ADDENDUM NO. 1

**Administration Building Renovation Re-bid
Compton Community College District**

tBP Project. No. 20987.00

tBP/ARCHITECTURE

COMPTON COMMUNITY COLLEGE DISTRICT
1111 E. ARTESIA BLVD.
COMPTON, CA 90221

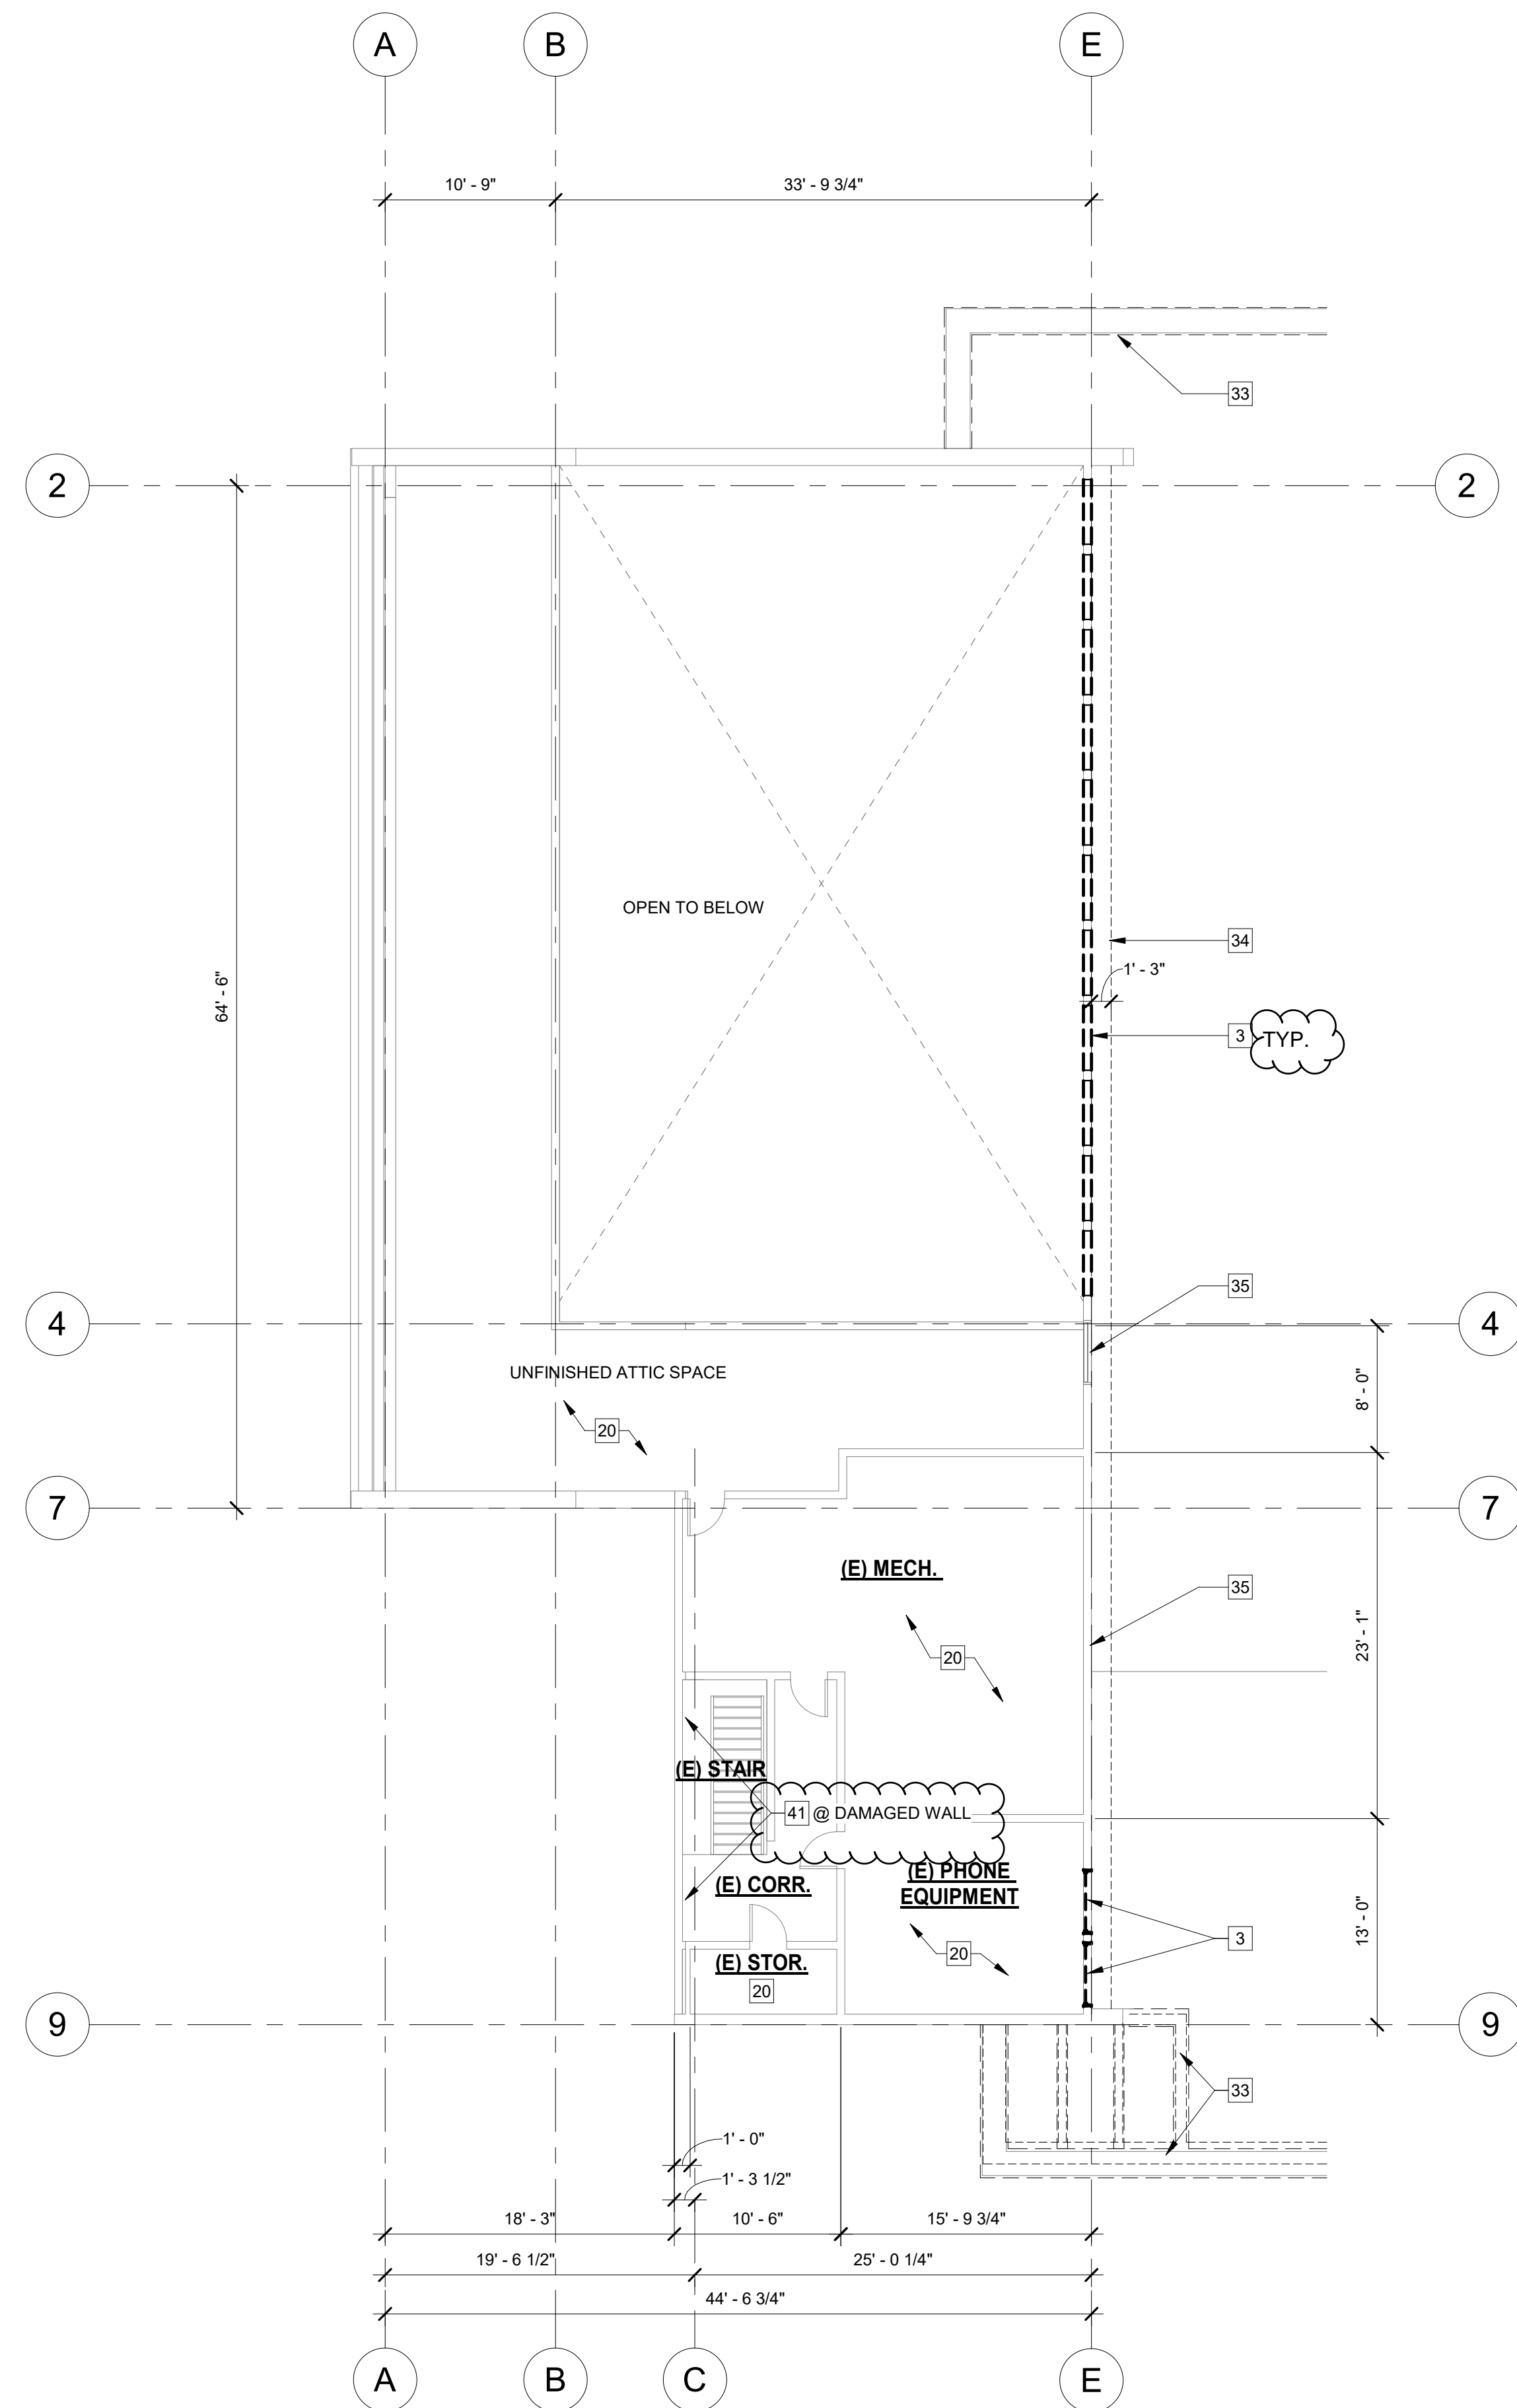
1. Revised SHEET AS-2 SITE DETAILS AND ACCESSIBLE PARKING

a. Included repair and slurry of asphalt area where new ADA parking is re-

- stripped.
- b. Revised all existing wheel stops to be new.
- c. Corrected detail references.
See attached revised Full size sheet identifying revisions included as part of this addendum.

drawing title:
FLOOR PLANS - DEMOLITION

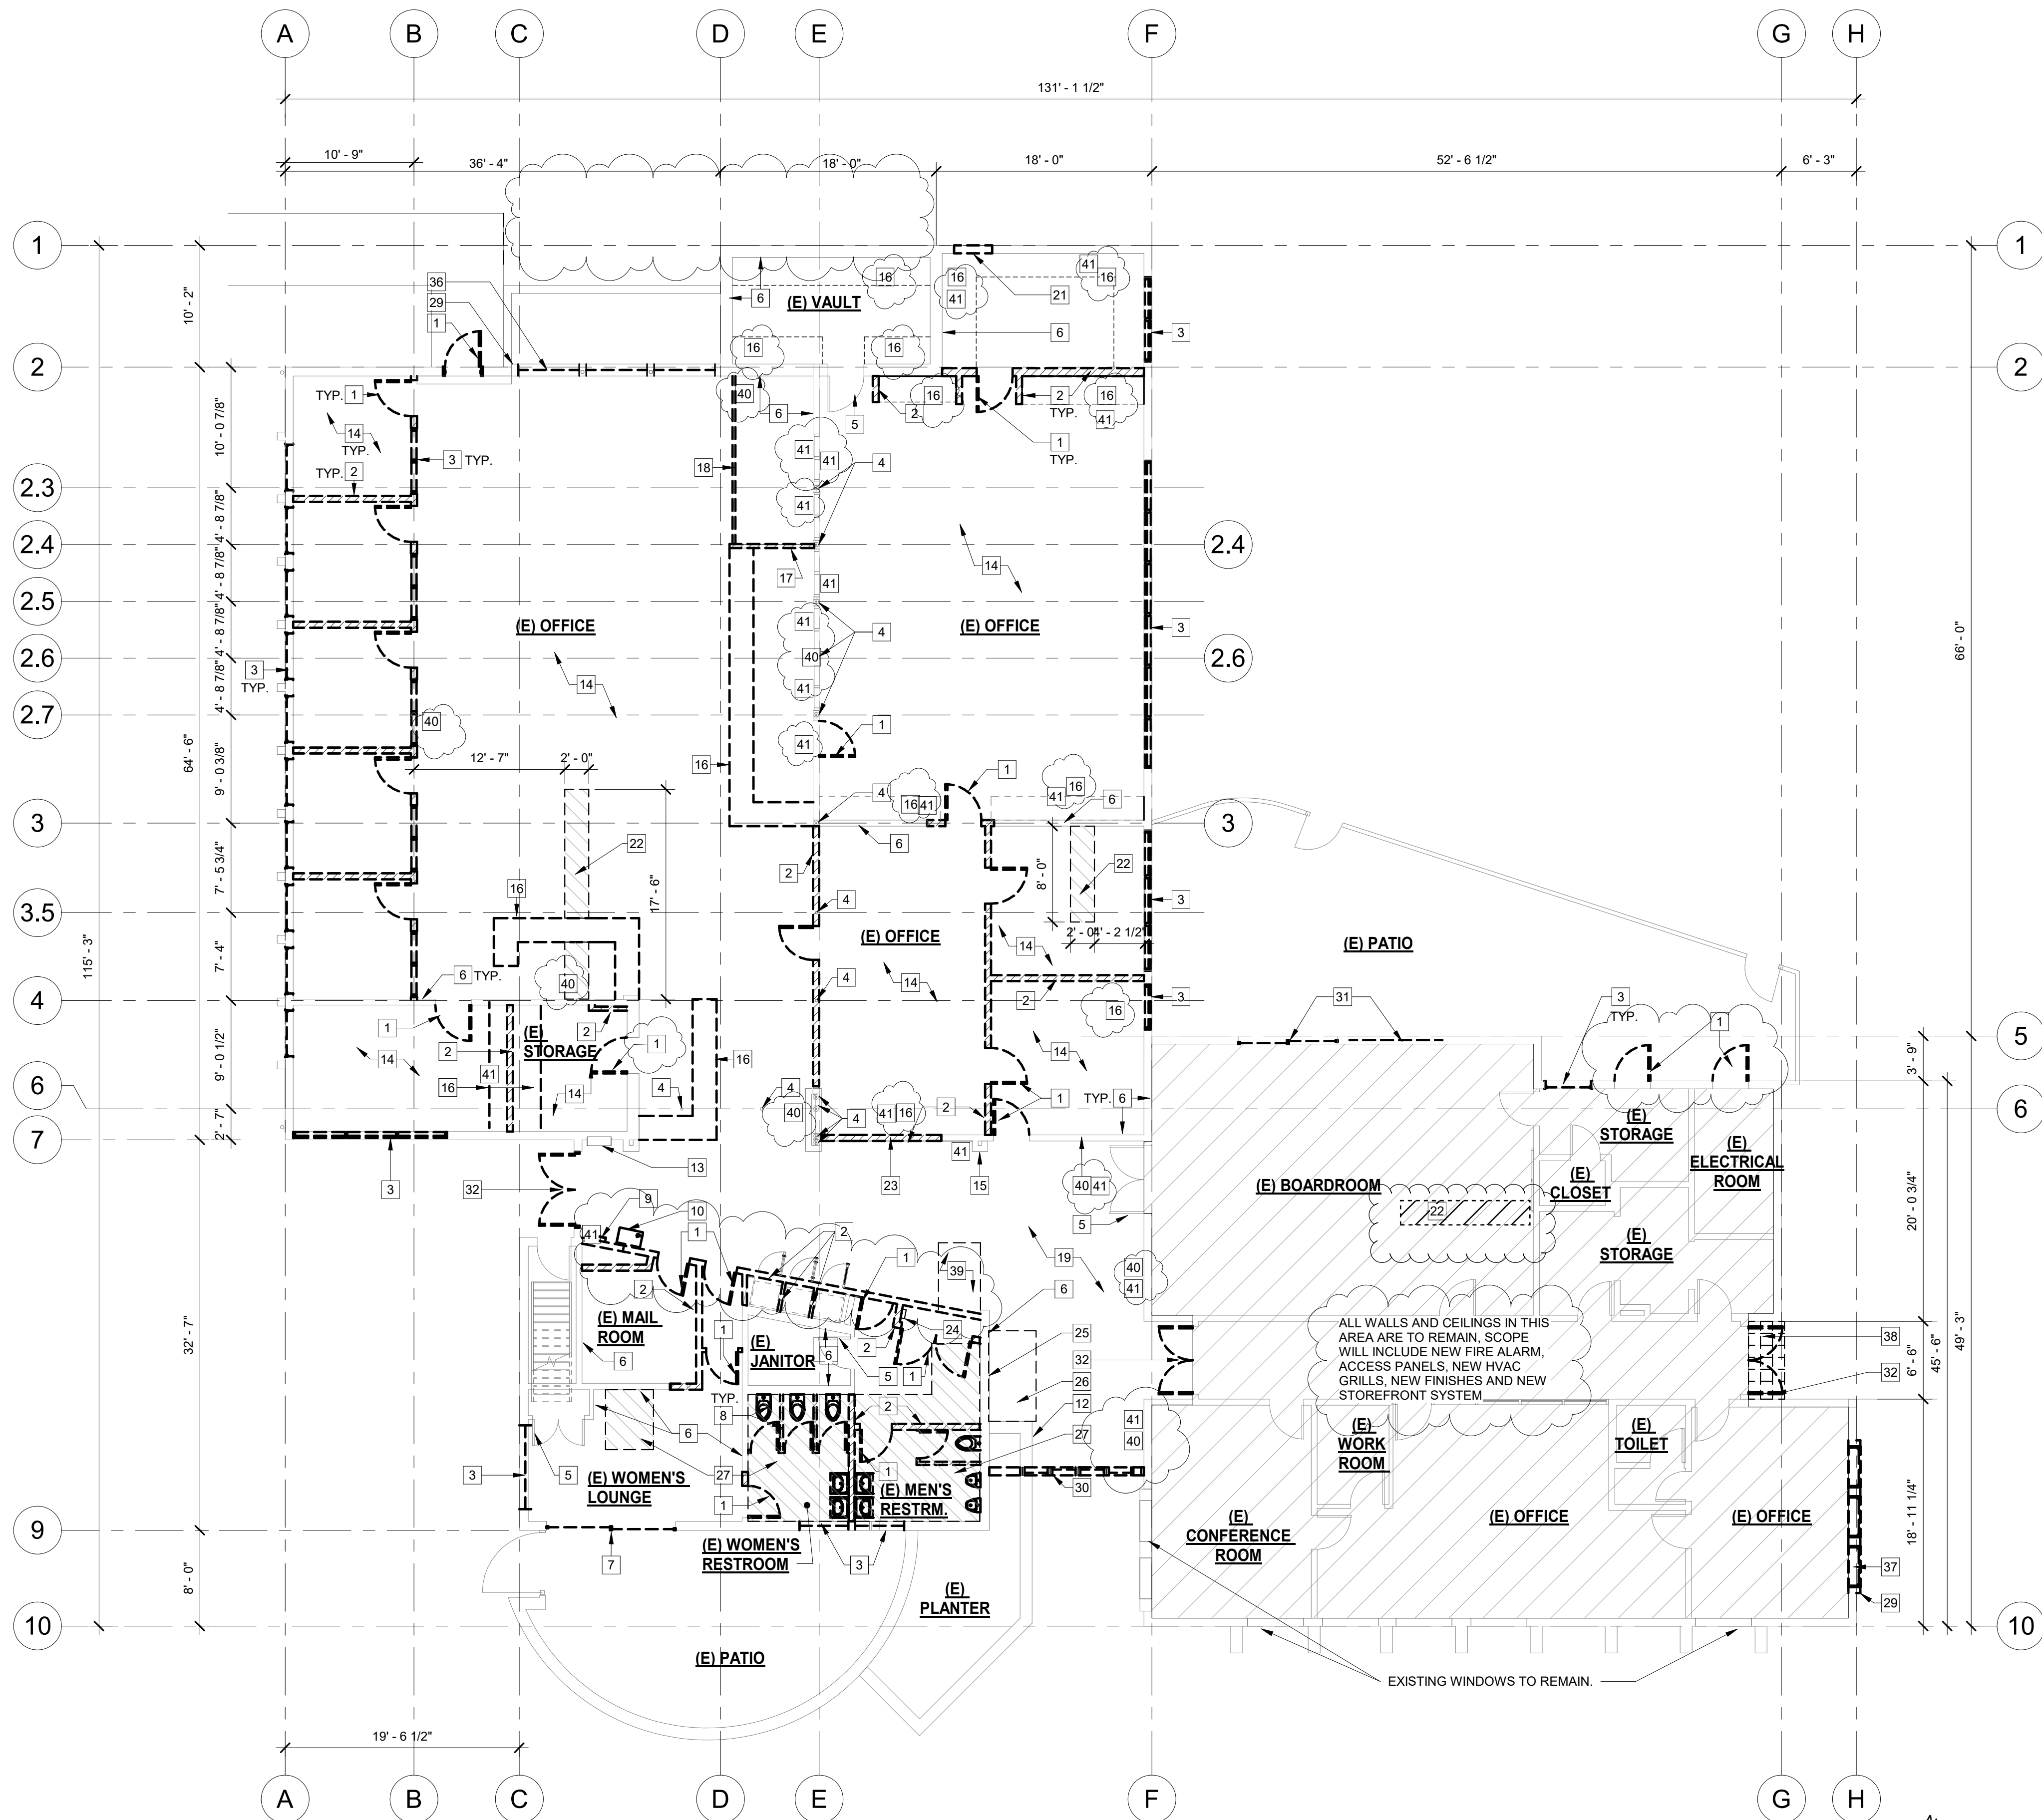
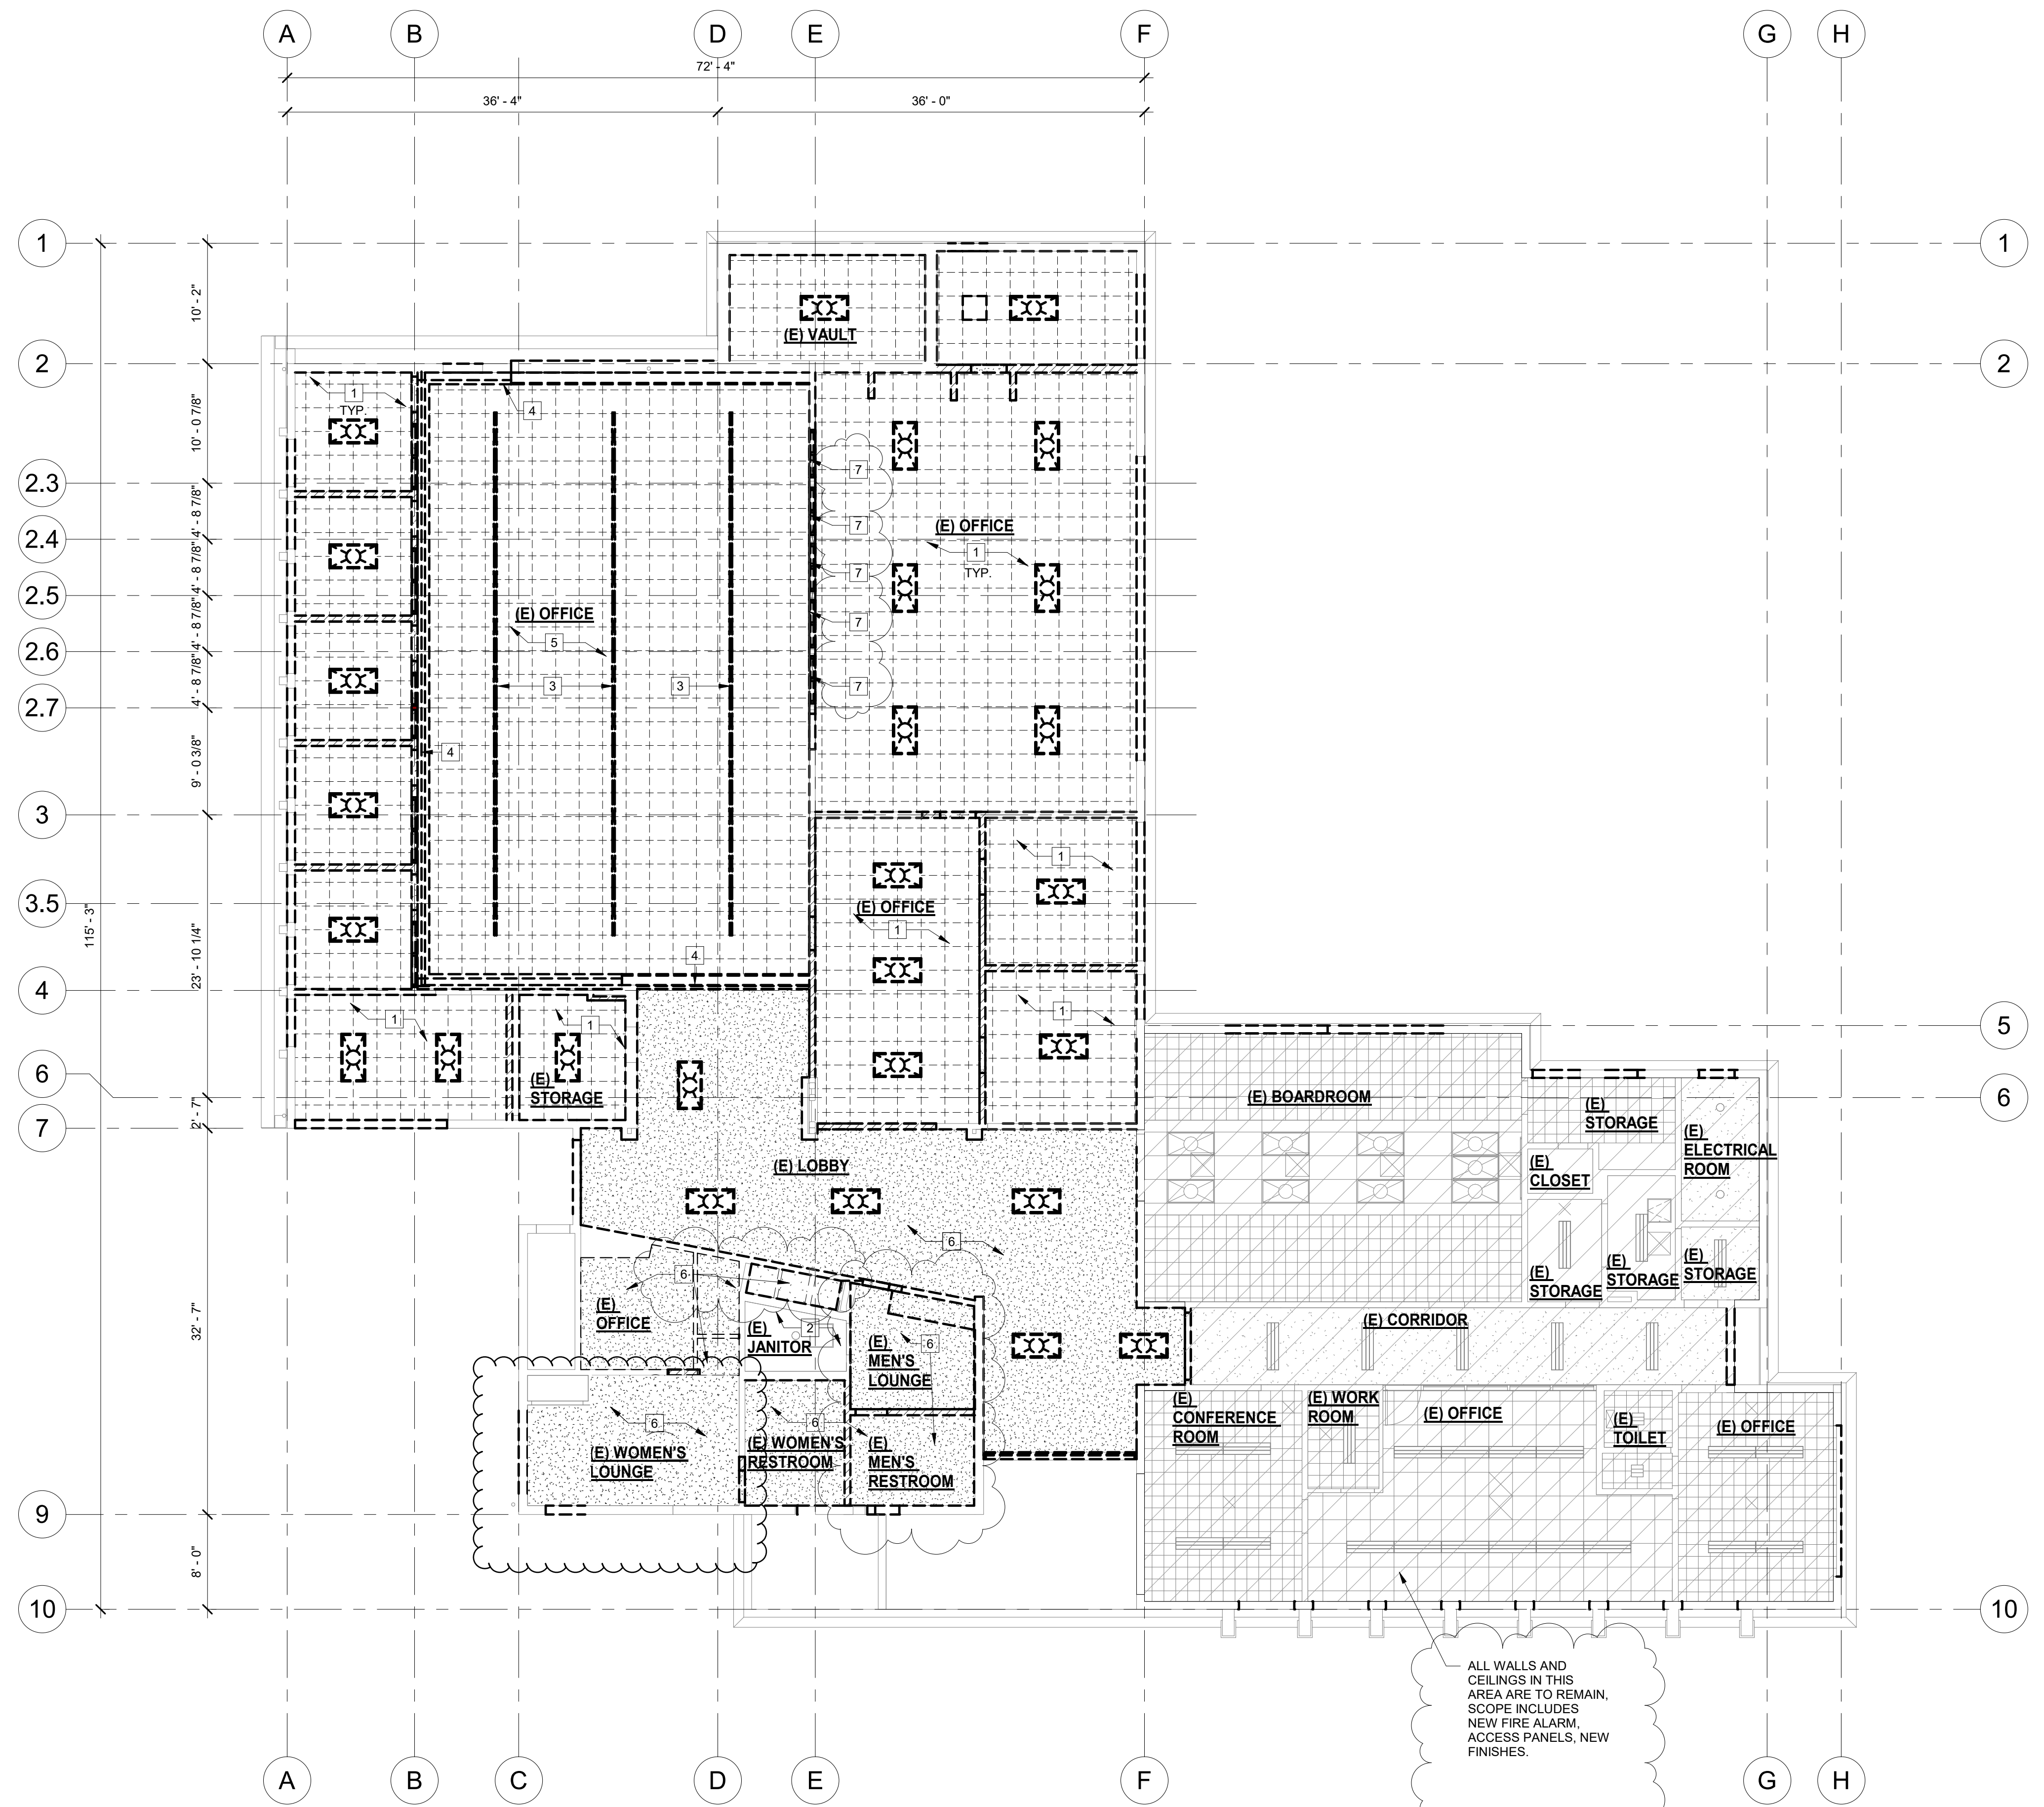
2. **Revised SHEET A0-1 FLOOR PLANS DEMOLITION.**

- a. Corrected general notes to clarify ambiguous scope notes.
- b. Include the replacement of two existing damaged exterior doors in the Electrical room and Storage room.
- c. Included the replacement of a wood window systems affected by termites.at the east side of the building.
- d. Added the demolition of the Lobby south wall (original building phone booths) and relocated new DF to this alcove created at this location.
- e. Added note 16 in several places where there were missing.
- f. Revised Key notes 13, 25, 29 and 37 Added key notes 39, 40 AND 41.
- g. Corrected graphics for wall to be remained shown as demo at grid line 2.
- h. Omitted the removal of the exterior sidewalk at the north side of the building.
- i. Added note and scope 22 to the existing boardroom.
See attached revised Full size sheet identifying revisions included as part of this addendum.
